## Architectural Commission Report

**Subject:** RITE AID (PL1412226)  
463 North Bedford Drive

Request for approval of a façade remodel and a sign accommodation to allow a greater sign area for a ground floor business located on a corner lot. The Commission will also consider adoption of a Categorical Exemption, pursuant to the California Environmental Quality Act.

**PUBLIC ELEVATIONS**  
 STORE#05461 WELLNESS REMODEL  
 463 N. BEDFORD DR.  
 BEVERLY HILLS, CA

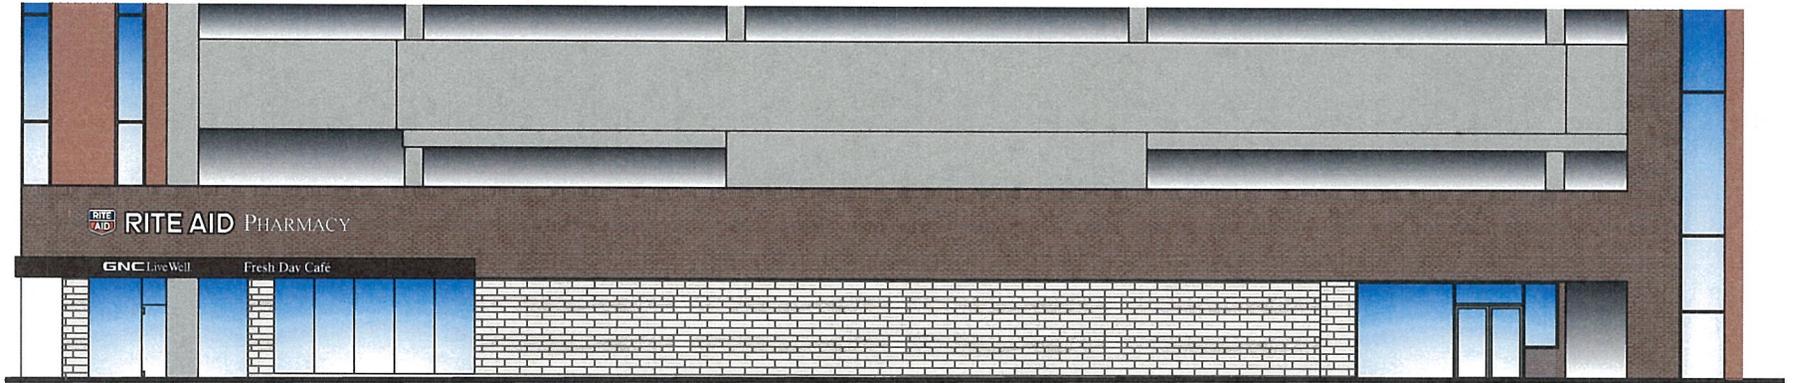
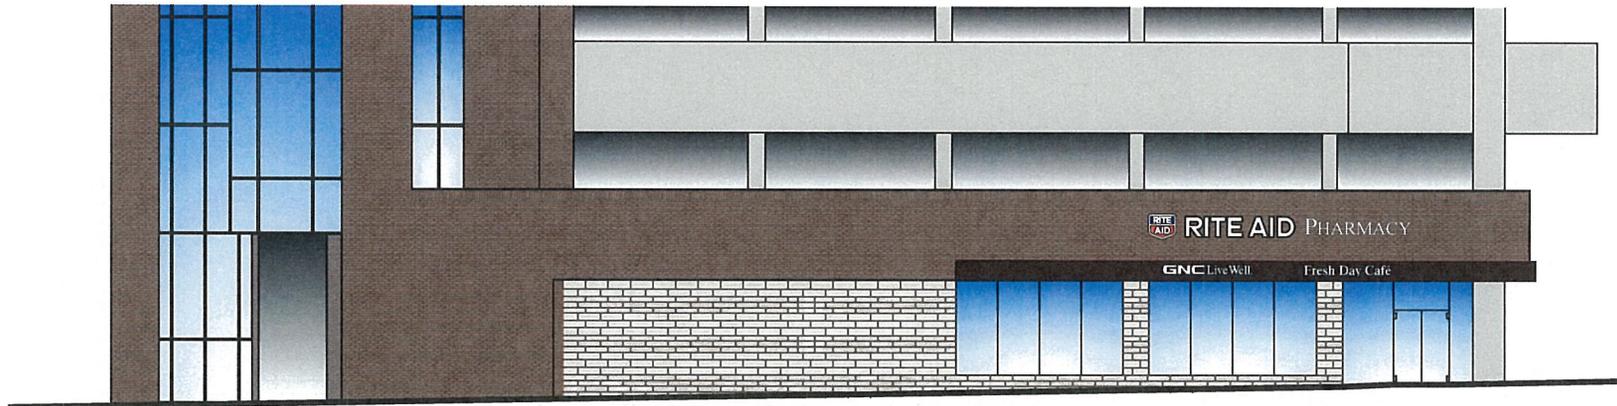
The proposed signage is tasteful and appropriate to the building and storefront and will serve to positively enhance the streetscapes of both North Bedford Drive and South Santa Monica Boulevard.
